# Redevelopment of Fort Street Public School Modification 2

State Significant Development Modification Assessment  
(SSD-10340-MOD-2)

June 2023

**Table 1 | Proposed modifications to school buildings**

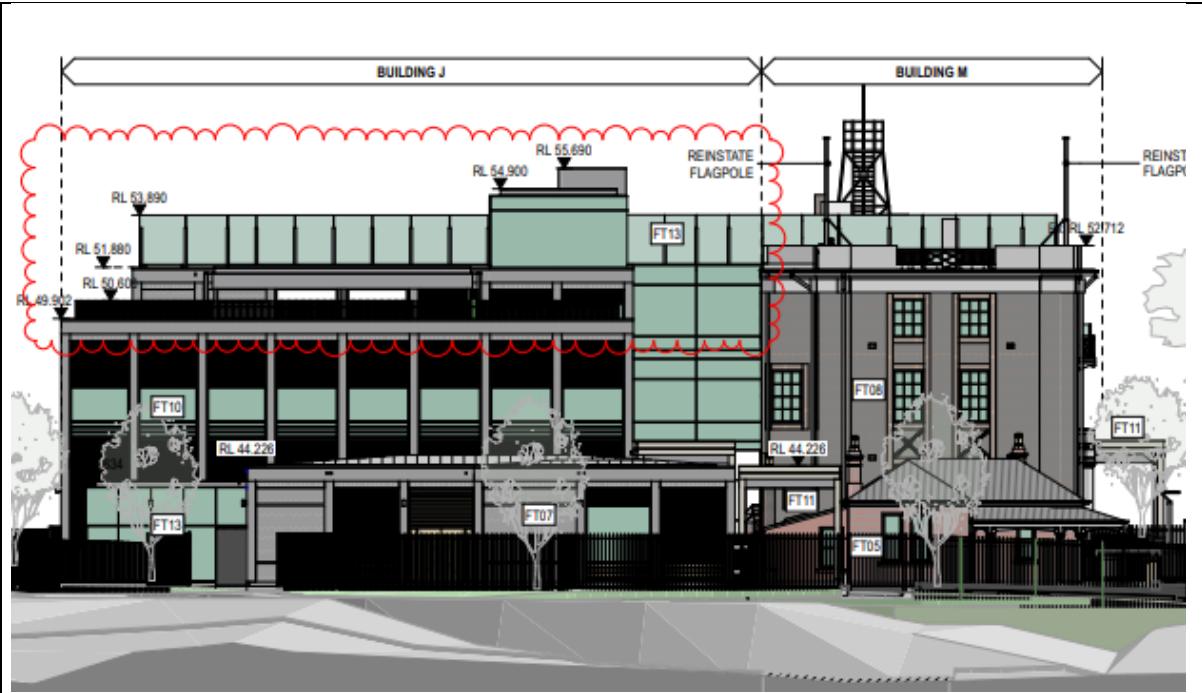
Building	Modifications
Building F	<ul style="list-style-type: none"> <li>Lowering of the entire building envelope by 260mm</li> <li>Finished floor level lowered from FFL 41.155 to FFL 40.895</li> <li>Parapet lowered from RL 45.197 to RL 44.937</li> <li>Lowering of external ground levels to align with the lowered building envelope.</li> </ul>
Building G	<ul style="list-style-type: none"> <li>Ground floor level lowered from FFL 39.754 to FFL 39.582 (172mm)</li> <li>Lowering of external ground levels to align with the lowered finished floor level.</li> </ul>
Building H	<ul style="list-style-type: none"> <li>Part of ground floor (adjoining Building G corridor) lowered from FFL 39.754 to FFL 39.582 (172mm)</li> <li>First floor level lowered from FFL 45.172 to FFL 45.086 (86mm)</li> <li>Minor external amendments to the sills and headers of the glass facades to accommodate the floor level change.</li> </ul>

Building J	<ul style="list-style-type: none"> <li>Lift shaft roof raised from RL 55.690 to RL 56.300 (610mm)</li> <li>Stair lobby roof raised from RL 54.900 to RL 55.210 (310mm)</li> <li>Lift lobby floor level lowered from FFL 40.170 to FFL 39.946 (224mm)</li> <li>First floor level lowered from FFL 45.172 to FFL 45.086 (86mm)</li> <li>Minor external amendments to the sills and headers of the glass facades to accommodate the floor level change.</li> </ul>
Materiality	<ul style="list-style-type: none"> <li>Additional solid/opaque fire rated spandrels to the bridges between the Met Building and Buildings H and J; and to the glazed facade of Buildings G, H and J.</li> </ul>

Figure 5 | East Elevation as approved and as proposed to be modified (Source: MOD 1 (above) and Applicant’s submission for MOD 2 (below))

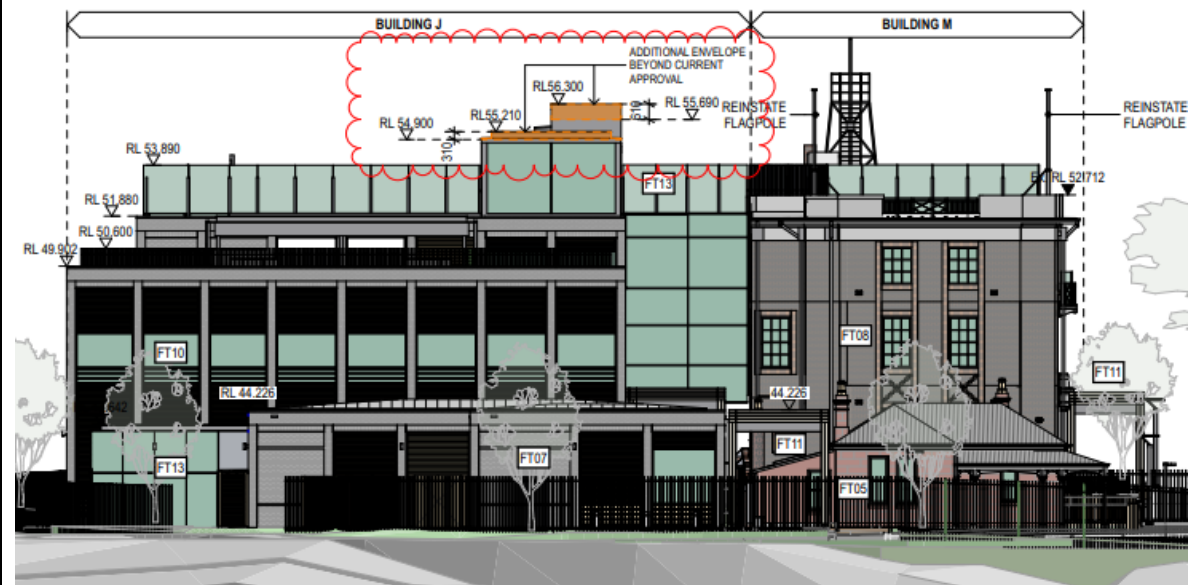
The Department notes amendments to the development approved under MOD 1 allowed the roof balustrading, lift overrun, and stair lobby of Building J to exceed the height of the Met Building. The design changes proposed as part of this modification further increase the height of the lift and stair elements.
